knitter-switch

Product-Change Notice P2022-06

Products affected: MERP 12-12126-GR, MERP 12-12P126-GR, MERP 12-12P126M9-GR, MERP 12-24N-225M, MERP12-24126GR, MERP12-24118.5M, MERP12-24126M, MERP12-24225-GR, MERP12-24225OB, MERP12-24225M9GR, MERP12-24-225M, MERP12-24N225M, MERP12-24126M9GR, MERP12-24126M9BG

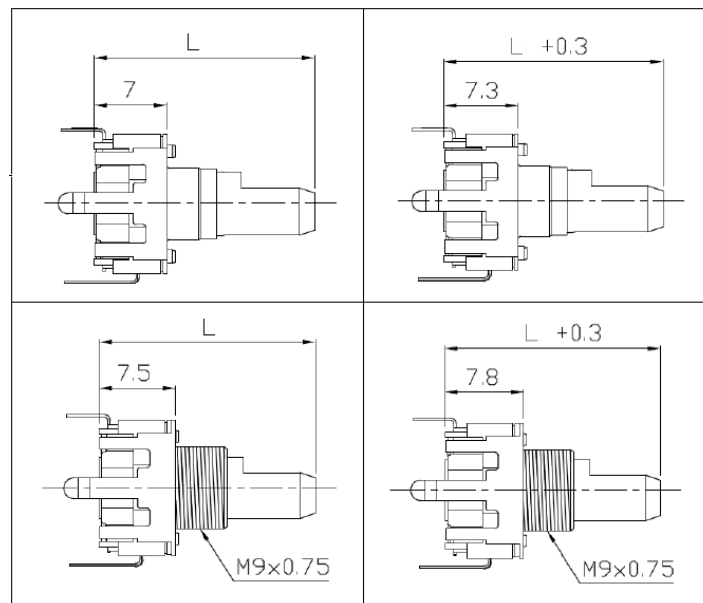
In course of continuous product improvement, to improve reliability and thermal stability, the thickness of lower case-part and internal LED block has been increased. This results in an increase of the body height of total 0.3 mm for all MERP 12 models (with pushbutton) with bicolour or RGB-LED illumination. The total height of the component is changing accordingly.
